Newsletter Technology Center Ice Generators  
July 2014

## New bearing arrangement for machines F200 to F600

New stainless steel housing bearing arrangement

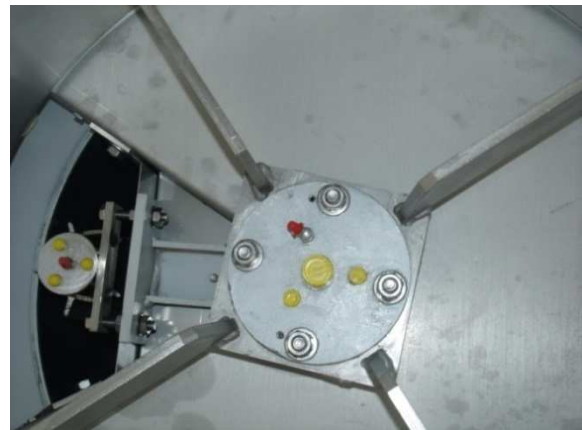
A new bearing arrangement is now used for the ice generators F200 and F250, this new bearing arrangement is described as an housing bearing arrangement.

**Since the 1.07.2014 these bearings are supplied in stainless steel on all our F200, F250 & F600**

It has to be noticed that these two bearing arrangements are not exchangeable, the new version cannot be installed on old machines. The following machines are concerned, the F200, F250, F600 ABF& SBF, PACKS 31 to 40.
